Interactive
Comment

Interactive comment on “Towards a stable and absolute atmospheric carbon dioxide instrument using spectroscopic null method” by B. Xiang et al.

Received and published: 22 May 2013

Fig. 1. Potential spectral region for cocurrent water measurement

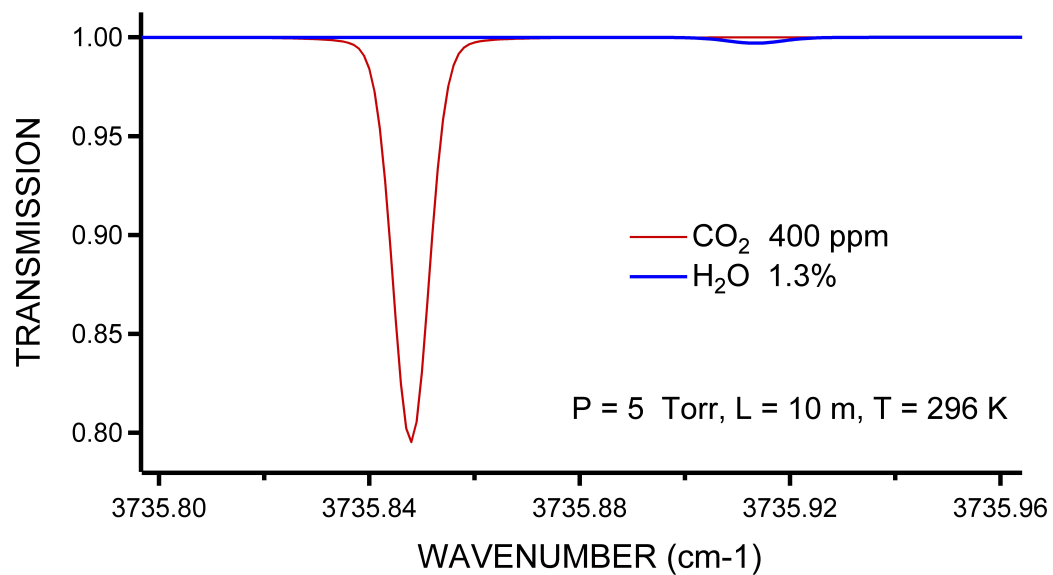
[RC] General remark: As pointed out in the conclusions, the major disadvantage of the instrument is the lack of concurrent measurement of H₂O. This would be a requirement for successful application in the field, since other techniques (e.g. CRDS) with proven reliability of the water vapor corrections are already commercially available (e.g. Rella et al, 2012).

[AC] Agreed. The manuscript already states that this is a disadvantage and that we have plans to address it by measuring water vapor. See below for one potential spectral region.
